2012 Polaris 600R IQ Team Tip #2

Wheel Spacer, 5134706

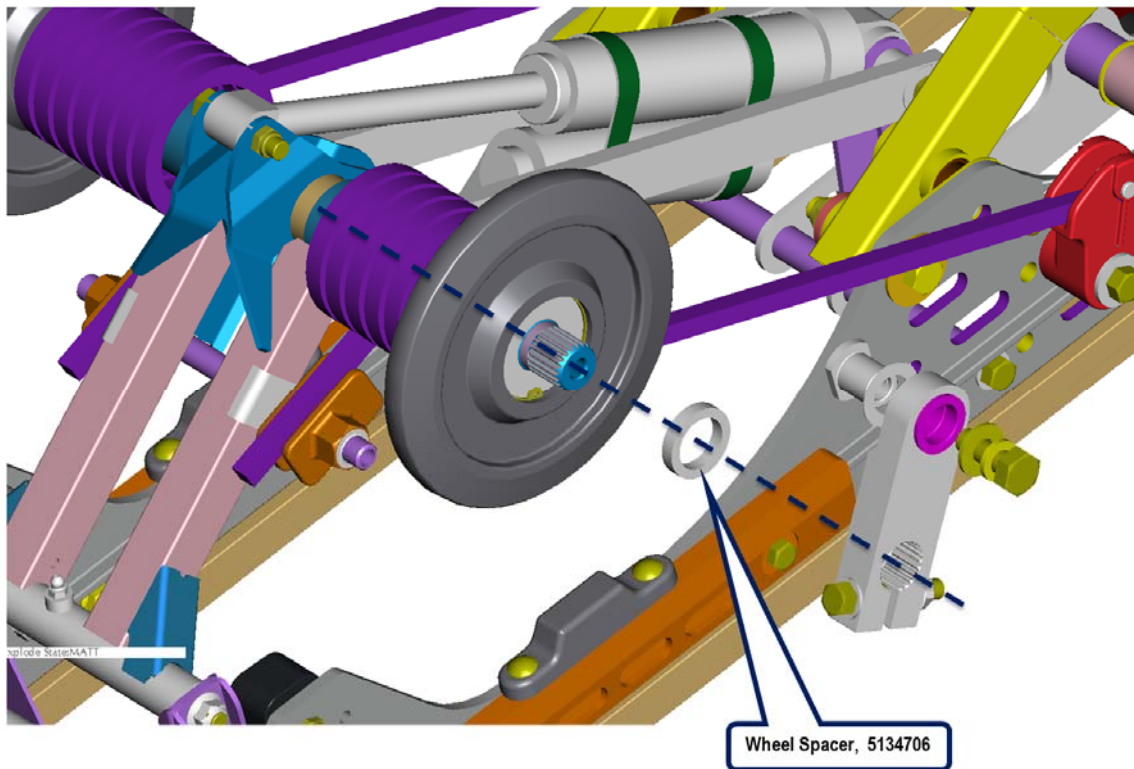
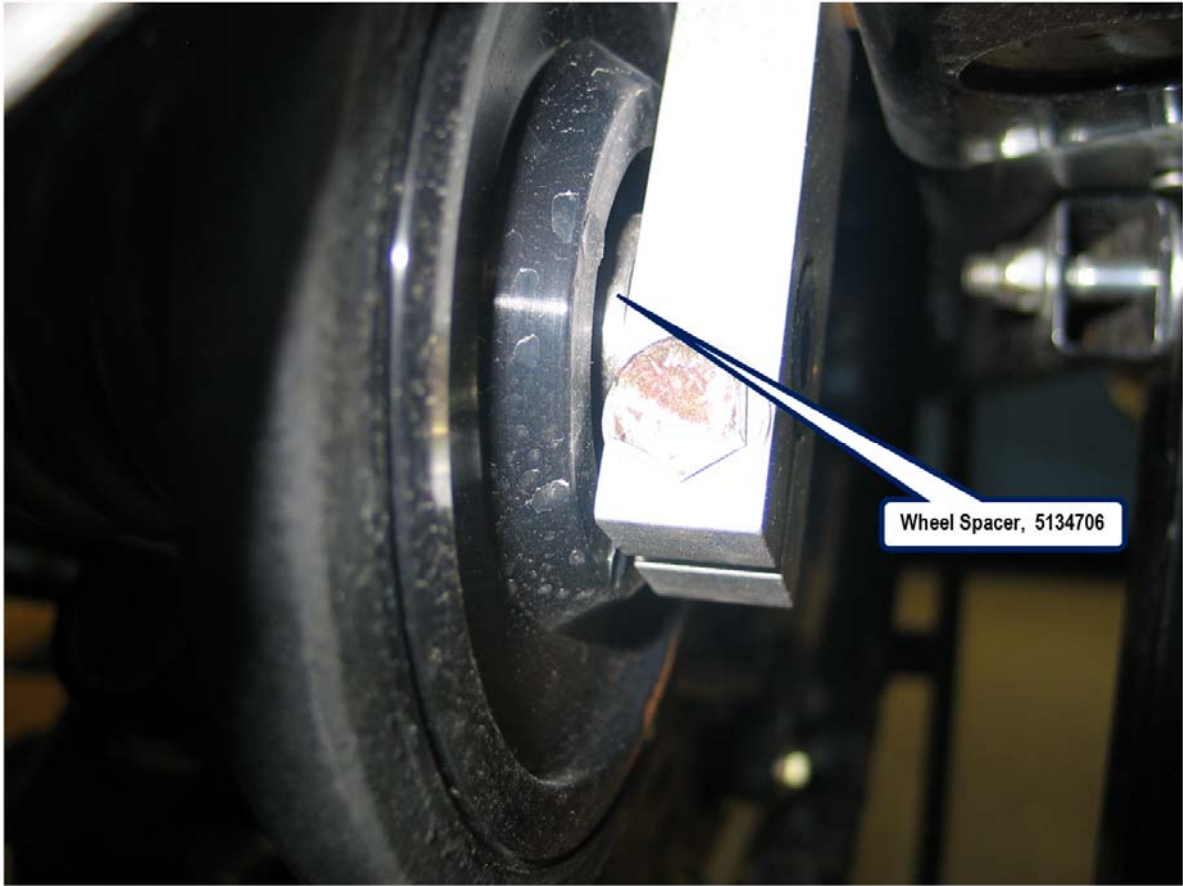
We have heard a few reports that one or both of the rear torque arm wheel spacers (Polaris part no. 5134706) were not installed during the assembly process. Running your vehicle without this spacer will potentially damage the rear suspension. Please verify the installation of both spacers on the rear torque arm. If missing, please contact Brad Seavers at the Polaris Race Department, (715)-355-3008.
